**REQUEST**

Current Zoning: N1-A (neighborhood 1-A)  
Proposed Zoning: UR-2(CD) (urban residential, conditional)

The petition proposes to allow a 14-unit townhome development on a vacant parcel located between Park Road and Wintercrest Lane and on the north side of Fairview Road.

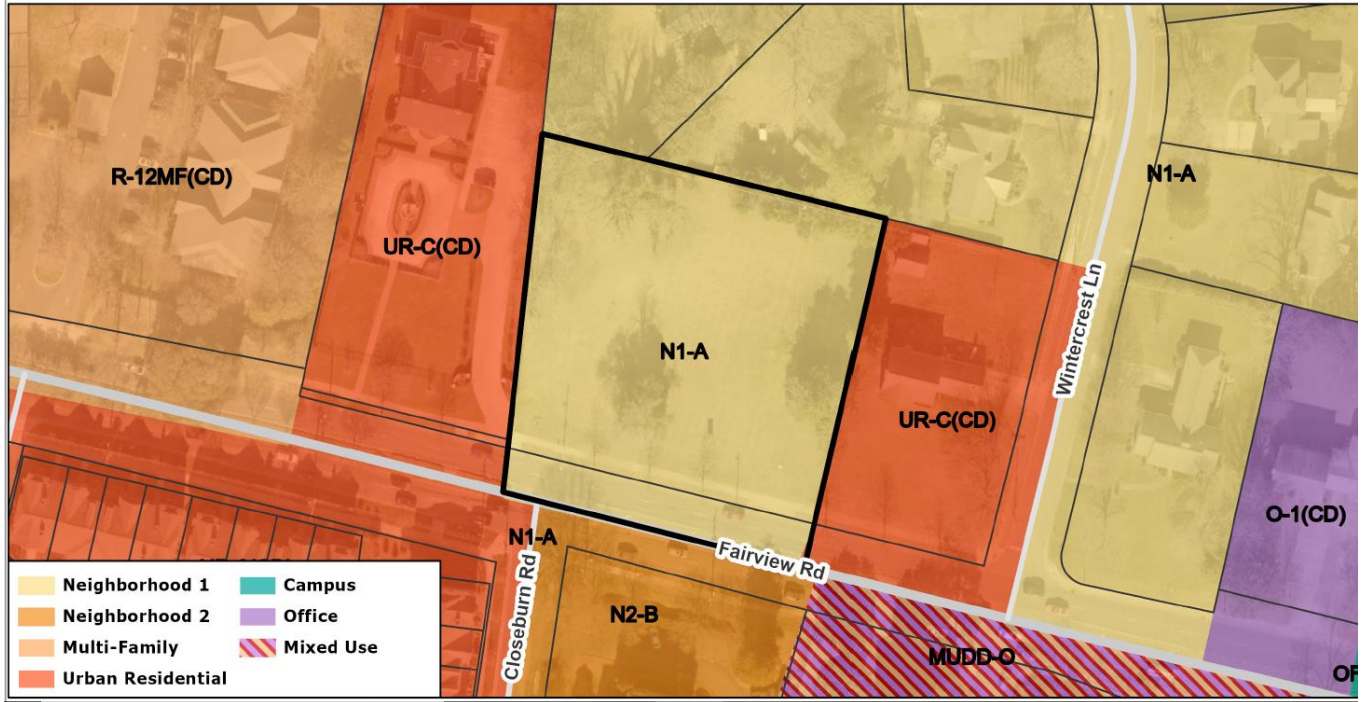
- ~~1. Limit the building height to 45 feet.~~ **Addressed**
- ~~2. Proposed eight-foot Class C buffer along east property line should be increased to 10 feet with language included it will not be reduced by 25%. Update: There is a discrepancy between labeling on the site plan and Note V.2. Please revise so note matches the graphic depiction of a 10' wide buffer.~~ **Addressed**

- ~~3. Amend Architectural Standards Note 4 to read "The units along Fairview Road shall provide a porch or stoop facing Fairview Road." The 400 square feet of private open space will be required by the ordinance anyway, so that language can be removed.~~ **Addressed**

- ~~4. Amend language to Limit the number of dwelling units in one building to four when fronting Fairview Road.~~ **Addressed**
5. The site plan shows a 15-foot sanitary sewer main line that runs parallel to a portion of the north property line. The petitioner needs to show and label the actual width of the sanitary sewer easement on the site plan. Provide a minimum 10-foot Class C buffer outside the sanitary sewer easement along the north property line. Show and label the buffer on the site plan and commit to this improvement in the development notes, specifying to not be reduced by 25%. **Rescind Petitioner's response: We are unable to make this commitment due to space limitations on site. We can commit to providing a buffer if the sanitary sewer easement is abandoned.**

- ~~6. A no-rise analysis wouldn't apply to this site. Please change "100-year storm no-rise analysis" to "downstream analysis."~~ **Addressed**

- Prohibits vinyl siding, excluding vinyl handrails, windows, soffits, doors or door trim; and concrete masonry units not architecturally finished.
- Notes that units having frontage along Fairview Road shall ~~contain~~ provide a porch/stoop that wraps a portion of the front and side of the unit to the extent that such porch/stoop may count toward the required 400 square foot private open space requirement, facing Fairview Road.

- Limits the number of dwelling units in one building to ~~six~~ four units or fewer when fronting Fairview Road.
- Specifies for units fronting Fairview Road, petitioner shall provide blank wall provisions that limit the maximum blank wall expanse to 20 feet on all building levels.

- Notes garage doors will not front Fairview Road.
- Proposes a minimum ~~eight~~ **ten (10)** foot-wide Class C buffer, ~~planted to 10-foot wide standards~~ along the east property line, to not be reduced by 25%.

- Notes petitioner shall work with Charlotte Water to partially abandon the existing 15-foot sanitary sewer main line parallel to the Site's northern property line and replace with a minimum 10-foot wide Class C buffer, to not be reduced by 25%.

- Petitioner shall provide peak flow control for the 100-year, six-hour storm runoff from the developed site to the predevelopment peak flow rate. The petitioner reserves the right to perform a ~~100-year storm no rise~~ downstream analysis of the Site to demonstrate that the additional peak control for the 100-year storm event is not needed.
